# ETHERNOVIA

Improvements to IEEE 802.1CB-2017  
Maintenance Item 0343

IEEE Contribution

Figure C-7—Protocol stack for relay system F in Figure C-4

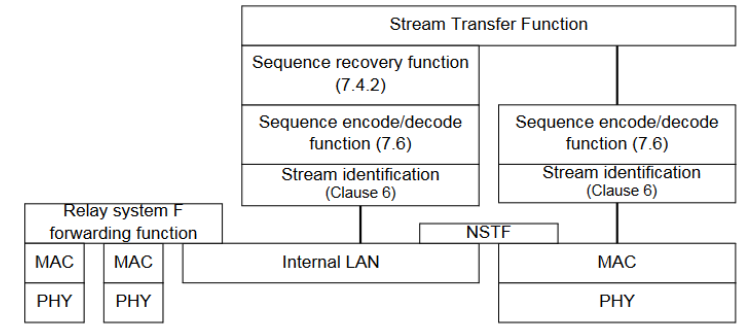
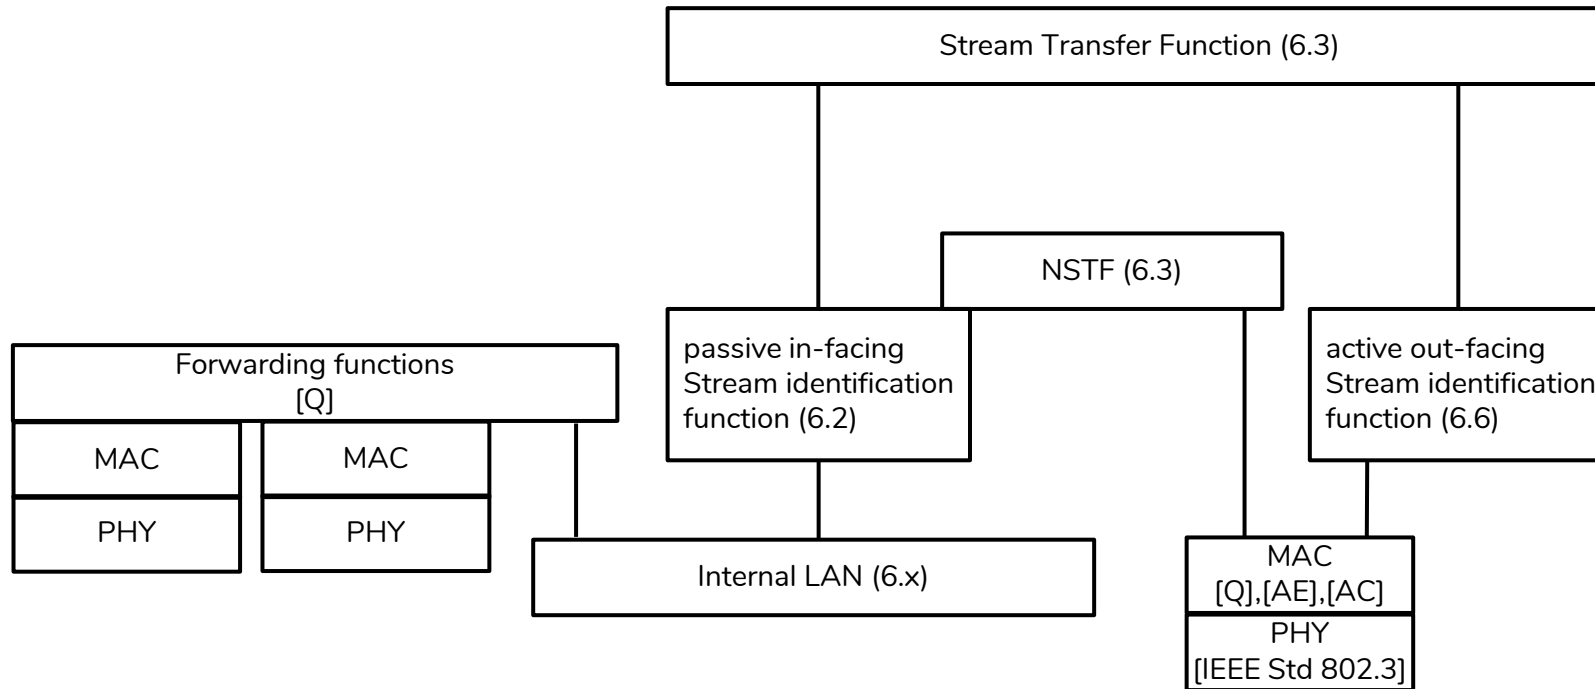
2. Section 8.1 j) “... take place after all forwarding (**except Queuing frames, 8.6.6** of IEEE Std 802.1Q-2014)” and Figure 8-2 contradict Figures 6-5, 6-6, 8-1, C-5, C-6, C-7, and C-12, as the later all show or imply ALL functionality of [Q]:8.6 to be encompassed by the “(Relay system) Forwarding function”.  
Since 8.1 j) and Figure 8-2 have been determined to be correct, the other figures need to be adapted accordingly.

# Modify Figure C-7

Figure C-10—Protocol interworking

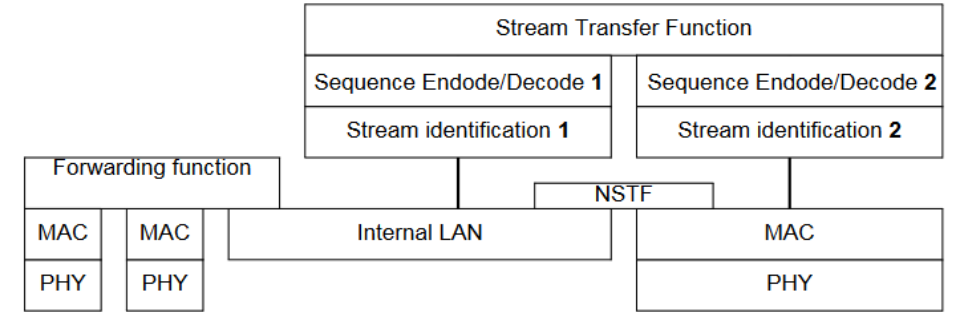
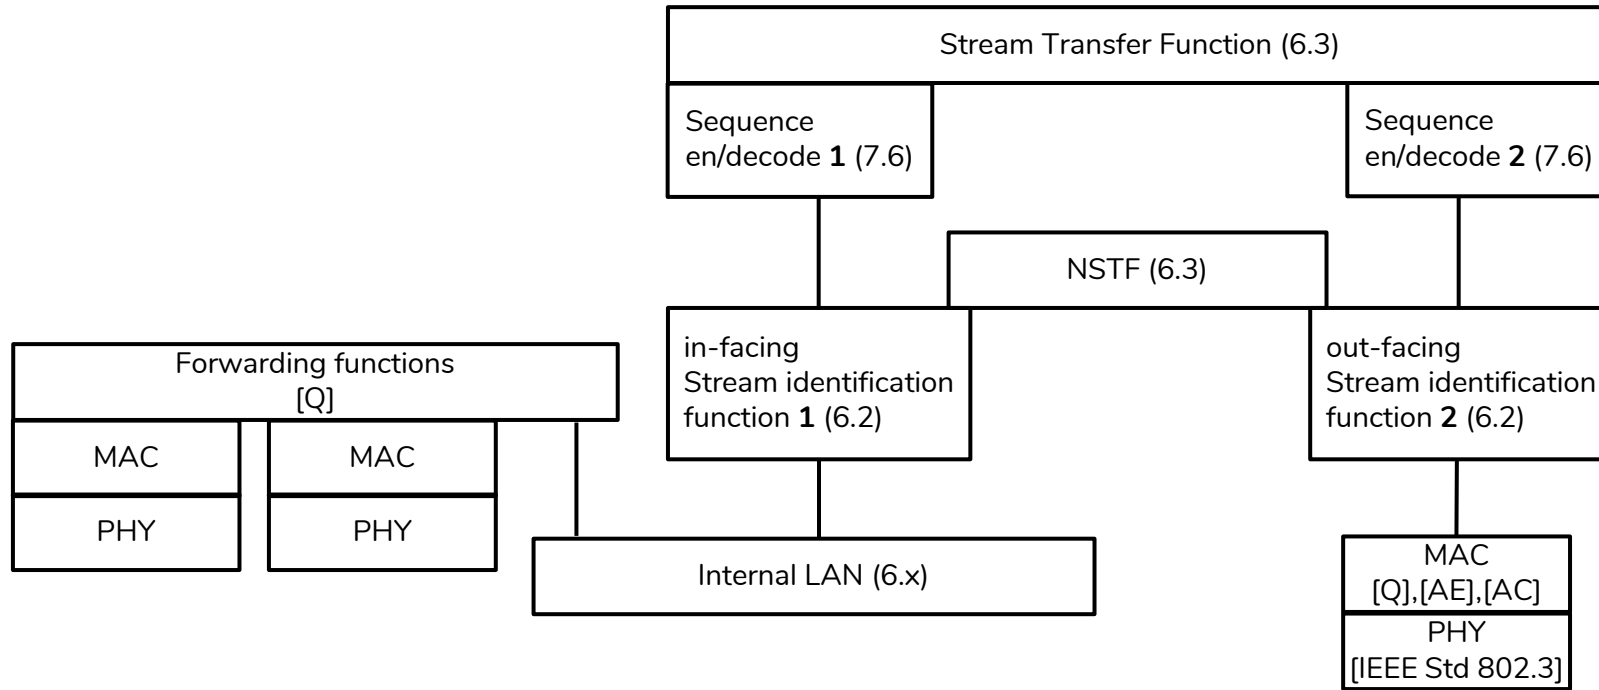
# Modify Figure C-10

Figure C-12—Protocol stacks for Systems B and G in Figure C-11

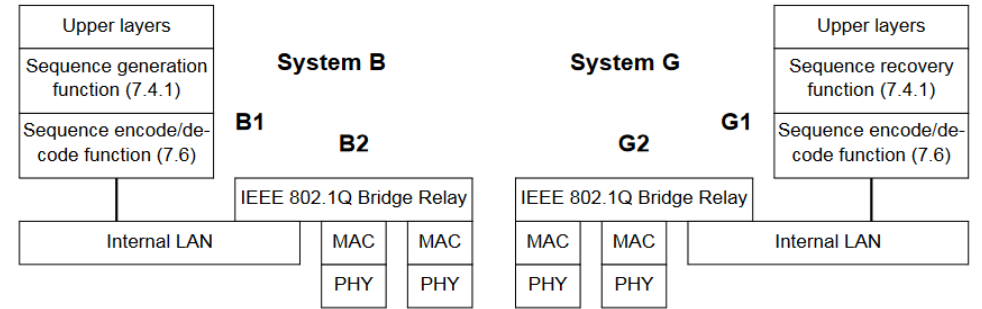
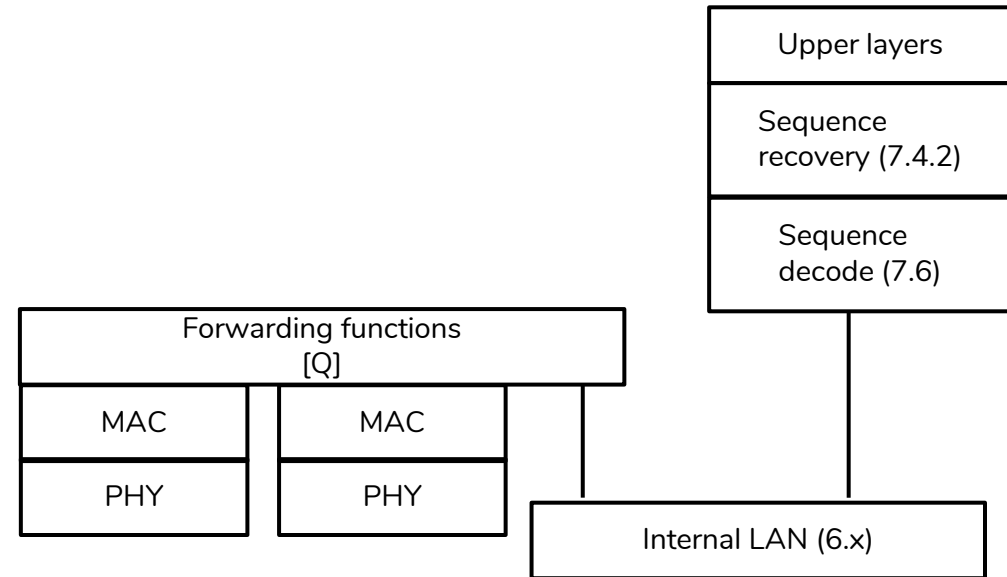
# Modify Figure C-12
